Final Mitigation Plan Six Runs Stream and Wetland Mitigation Project

DMS #: 100170 | Contract #: 0303-01 | RFP: 16-20190303
USACE Action ID: SAW-2020-01964 | DWR #: 20201798 v1
Cape Fear River Basin | HUC 03030006 | Sampson County, North Carolina

SUBJECT: NCDMS Six Runs Mitigation Project - NCIRT Comments during 30-day Mitigation Plan Review, Sampson County, NC

RE: Response to Final Draft Mitigation Plan Comments – Six Runs Mitigation Project (DMS #100170) Cape Fear 03030006; Sampson County, NC; Contract No. 0303-01

Figure 10 - Conceptual

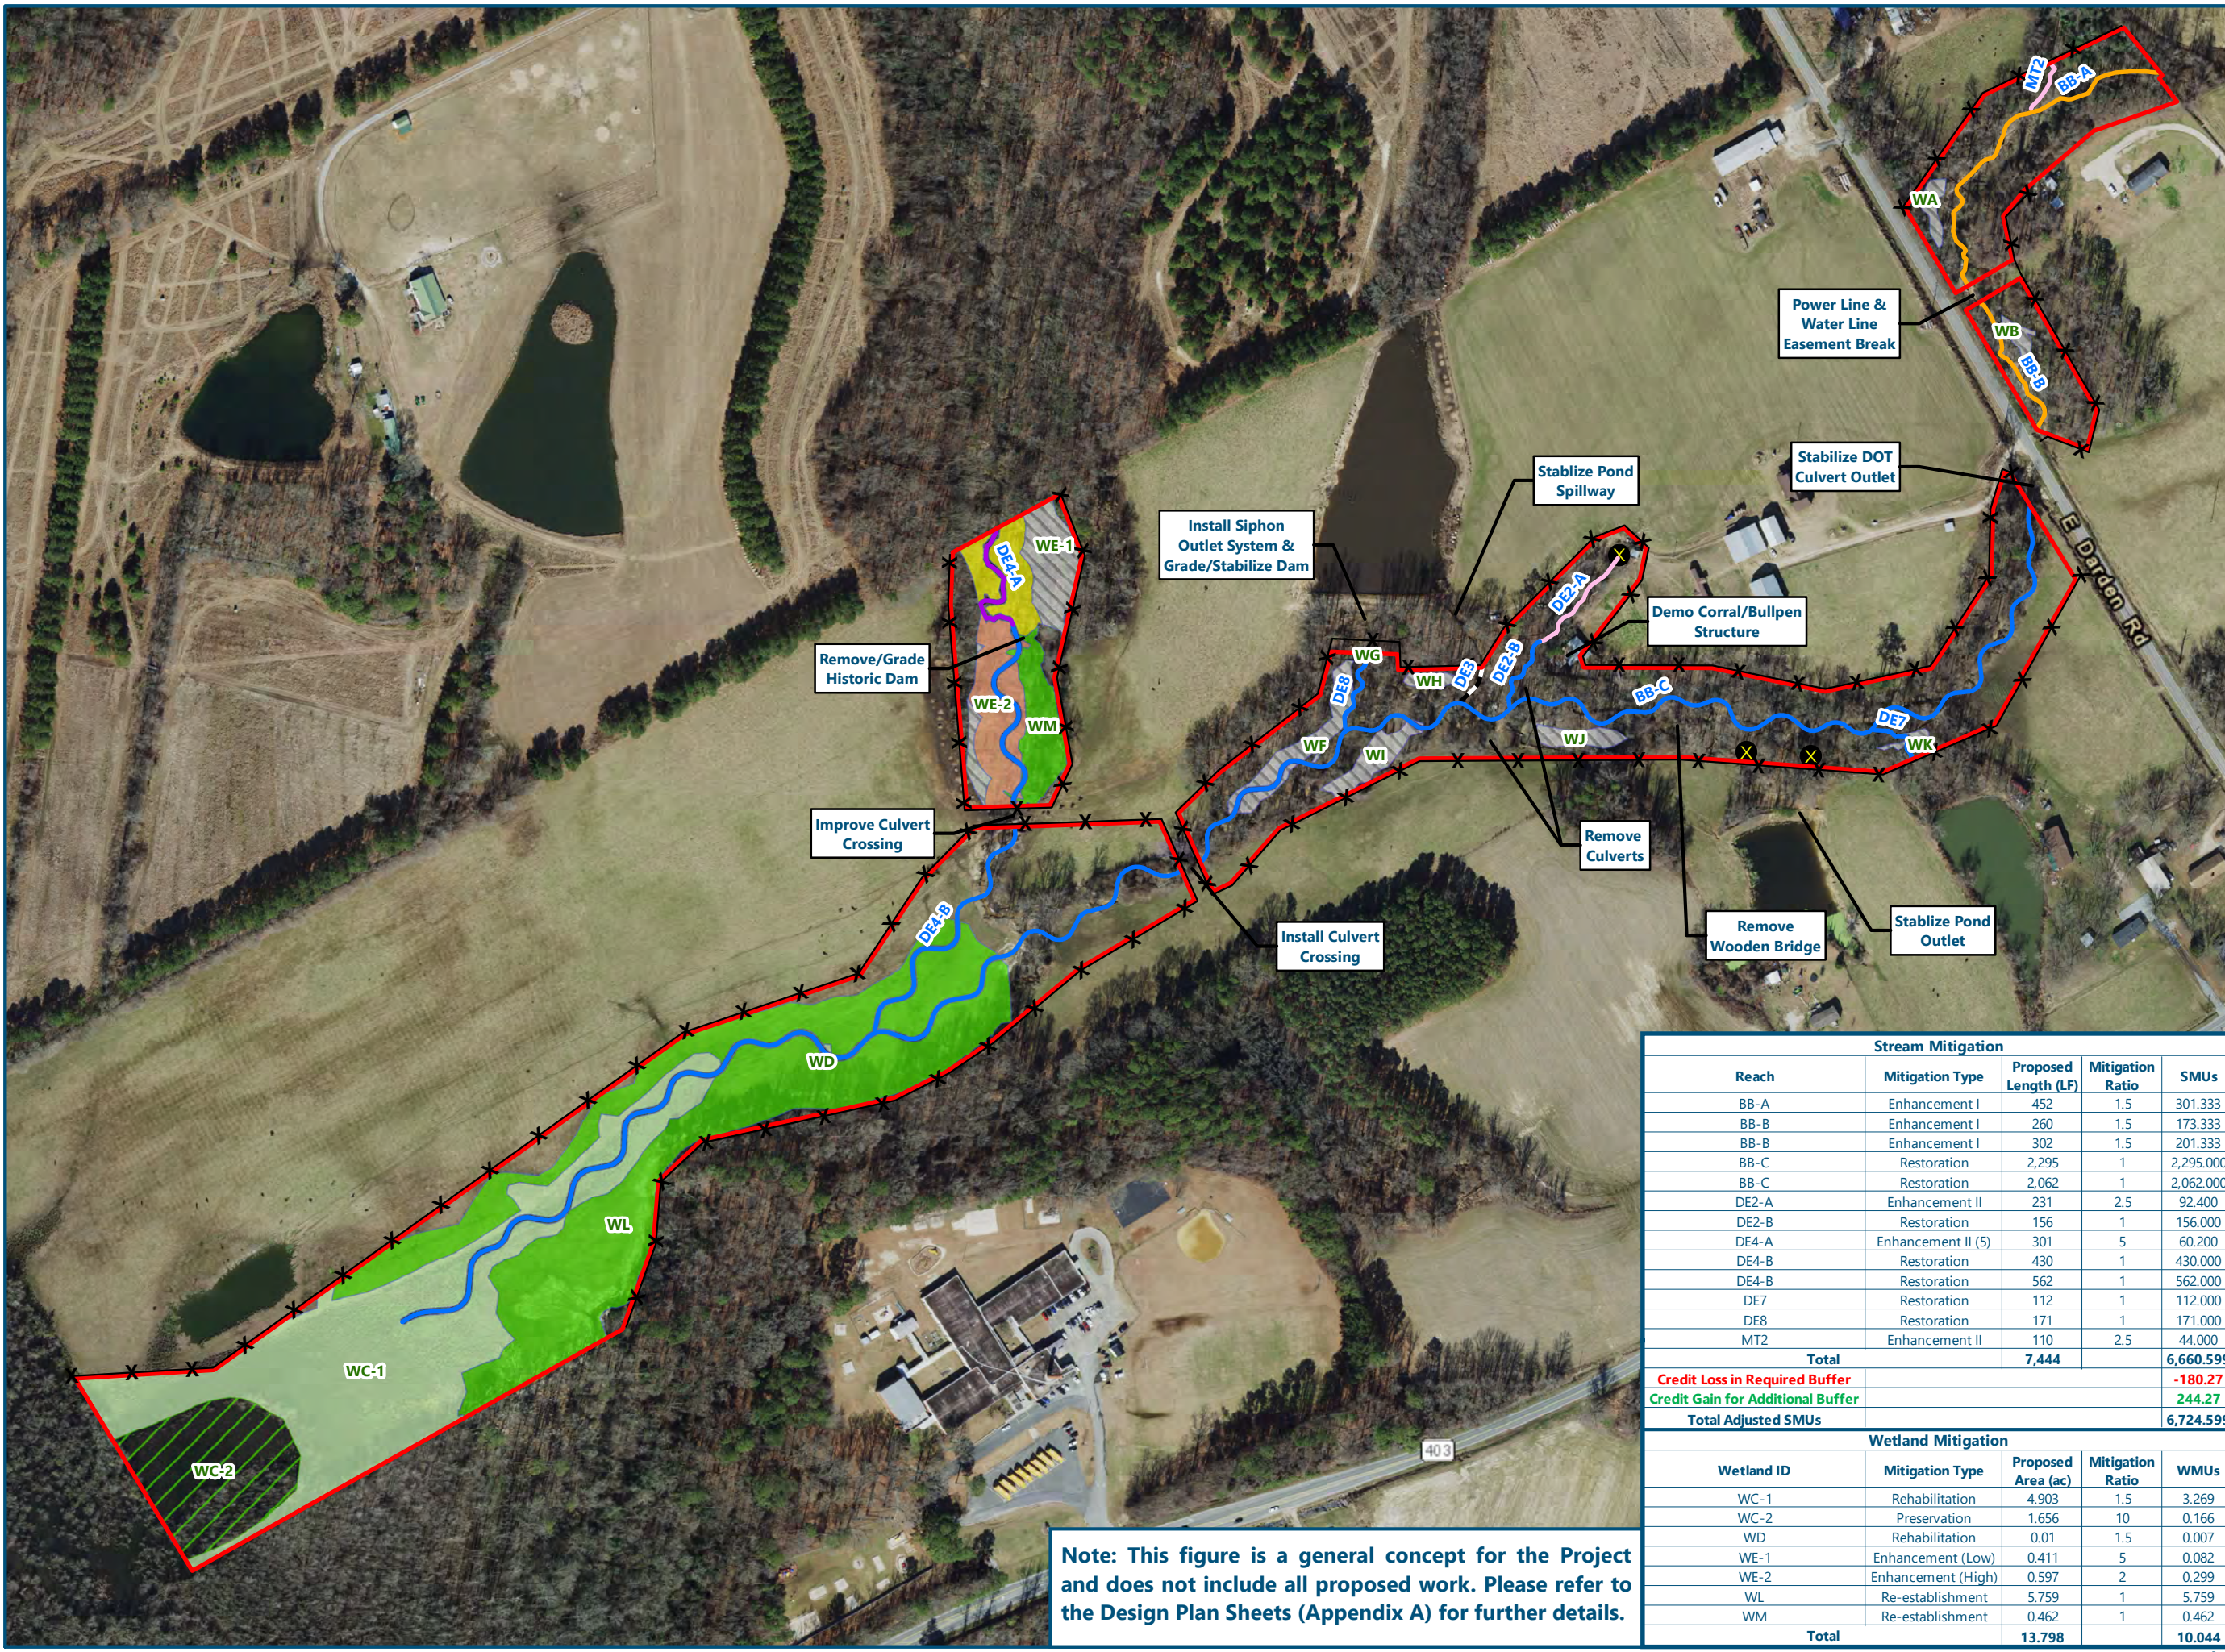
1. Figure 10 – There are some significant things missing from this figure that are shown or provided in more detail than the plan sheets. Suggest adding footnote that the Figure 10 doesn't include all proposed work and refers to plan sheets for details.
2. Figure 12 Monitoring. The location of the flow gauge on BB-A should be moved up closer to the top of the reach to show flow above the confluence of MT-2.

1. Figure 10 – There are some significant things missing from this figure that are shown or provided in more detail than the plan sheets. Suggest adding footnote that the Figure 10 doesn't include all proposed work and refers to plan sheets for details.

Note: This figure is a general concept for the Project and does not include all proposed work. Please refer to the Design Plan Sheets (Appendix A) for further details.

Figure 11 - Non-Standard Buffer Zones

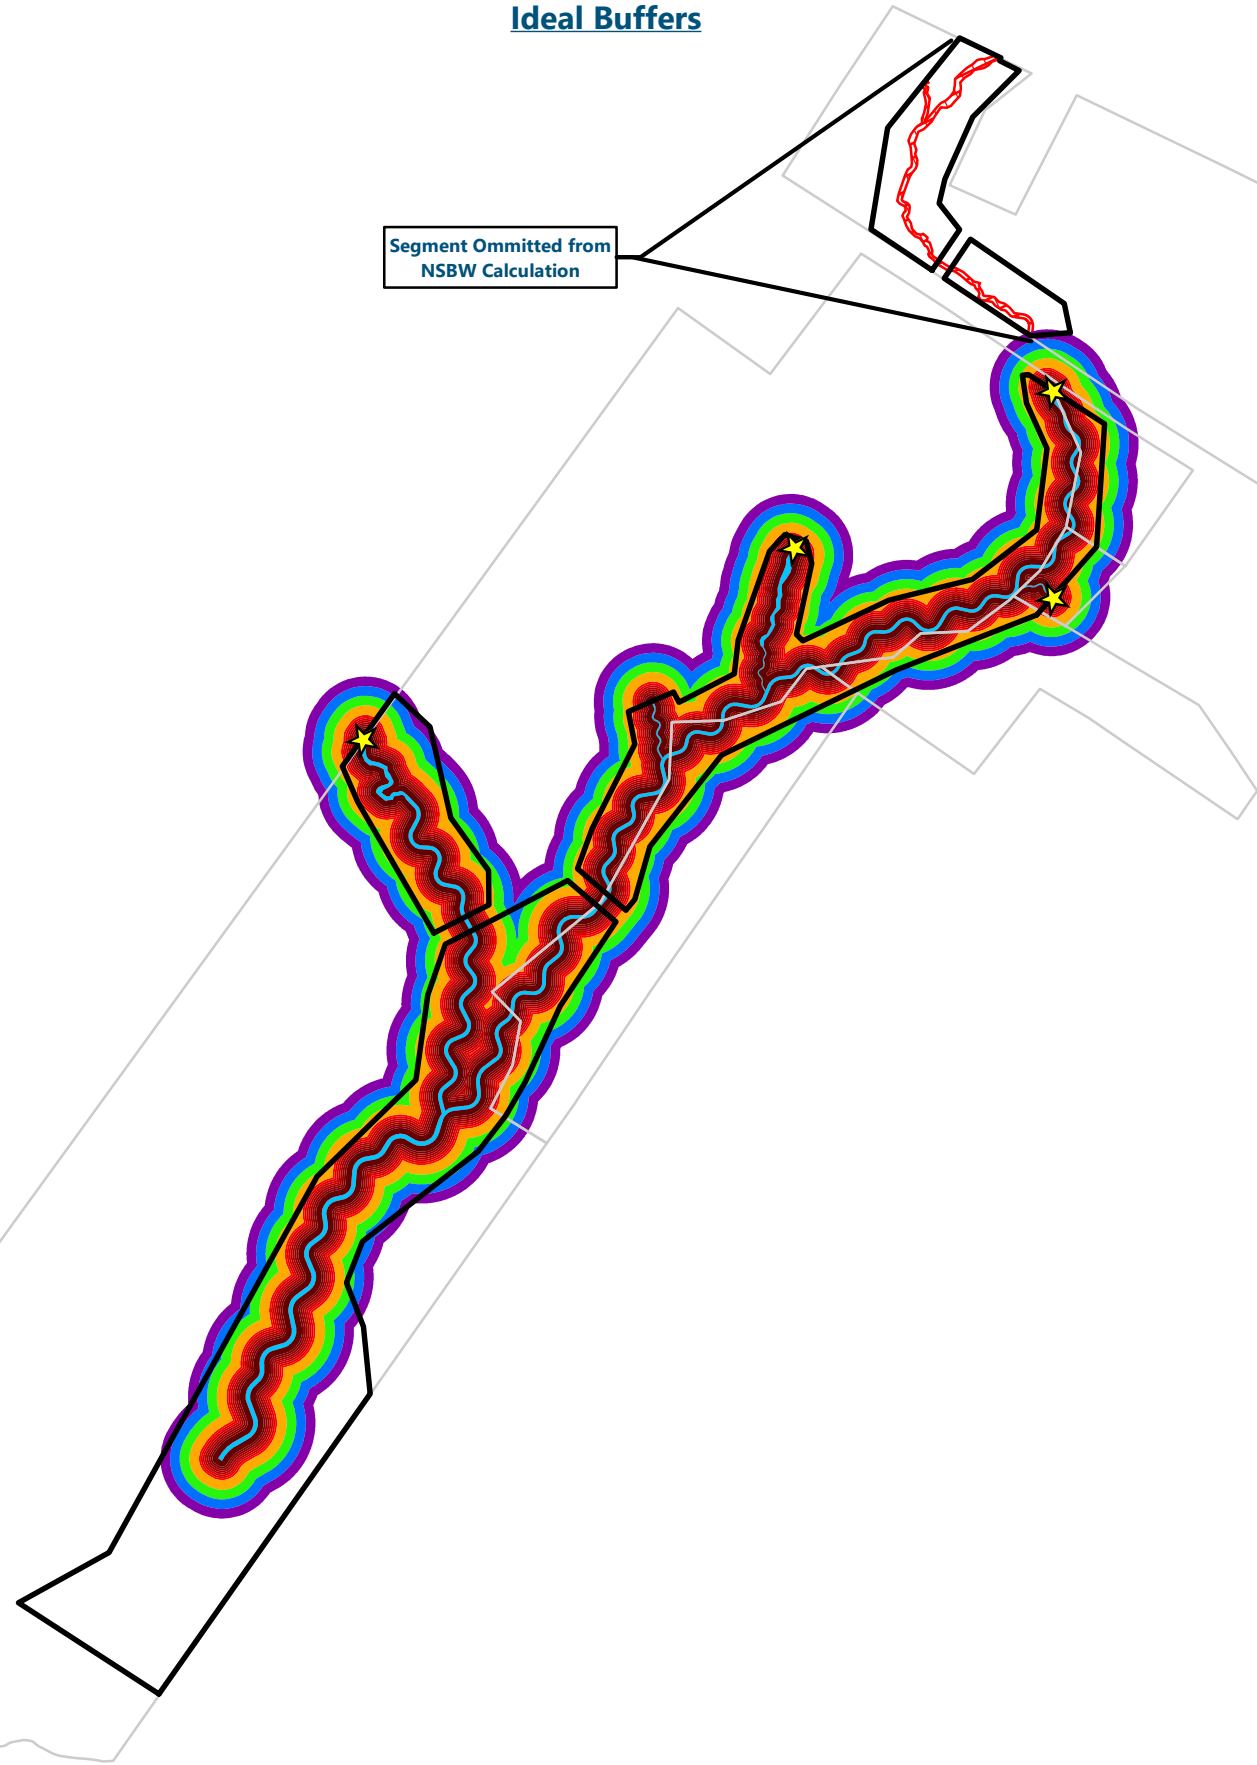
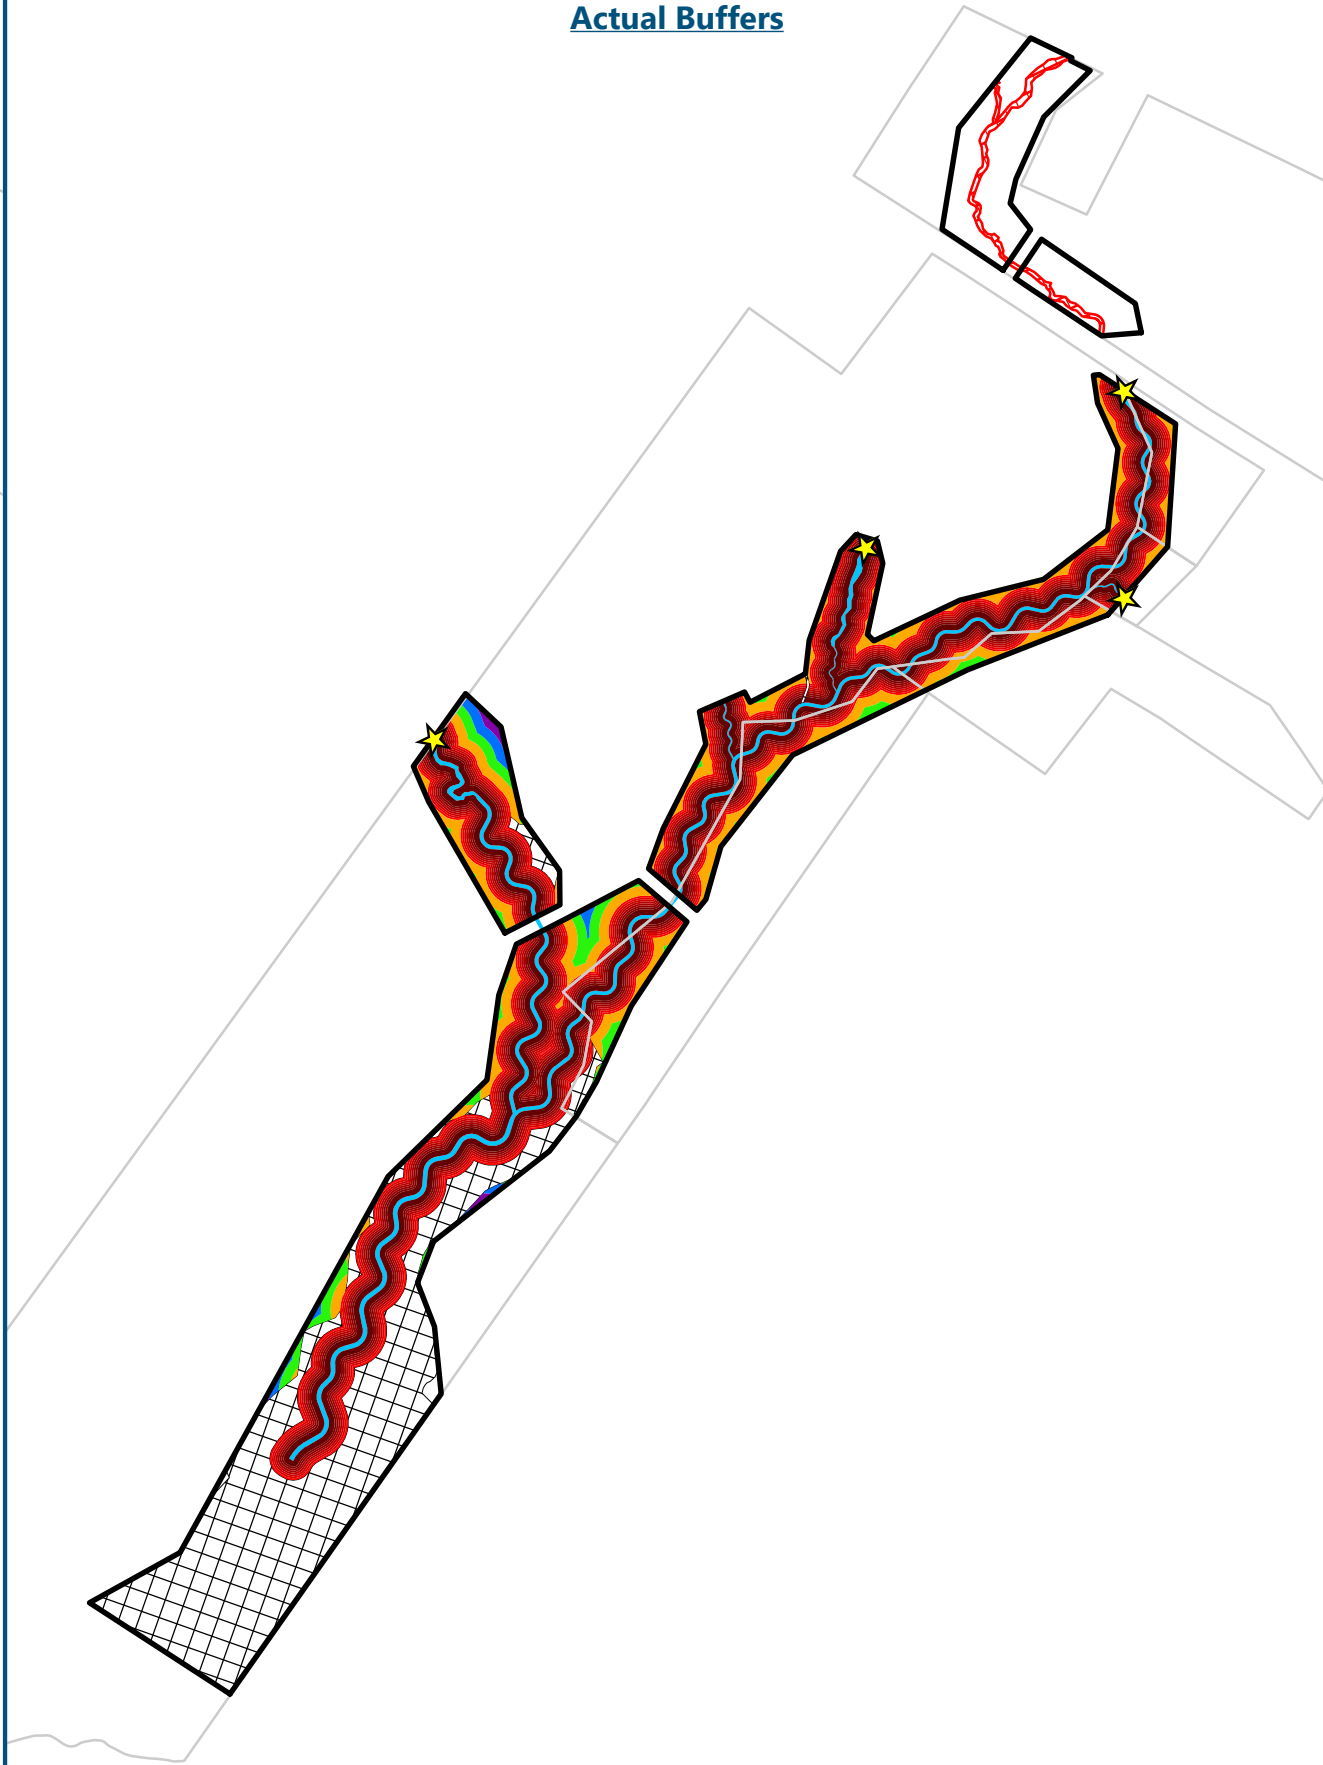
1. Figure 11: It appears that not all areas that are generating wetland credit were clipped from the buffer calculation. For example, the wetlands along DE4-A and the confluence of DE4-B with Brad's Branch. Please confirm. Also, from what I can gather from figure 3, there should be 7 exempt terminal ends. I'm happy to discuss prior to the final plan submittal.

1. Figure 11: It appears that not all areas that are generating wetland credit were clipped from the buffer calculation. For example, the wetlands along DE4-A and the confluence of DE4-B with Brad's Branch. Please confirm. Also, from what I can gather from figure 3, there should be 7 exempt terminal ends. I'm happy to discuss prior to the final plan submittal.

As for the terminal ends, due to the revised NSBW method used for this Project, there are now three exempt terminal ends. These are now depicted on **Figure 11**.
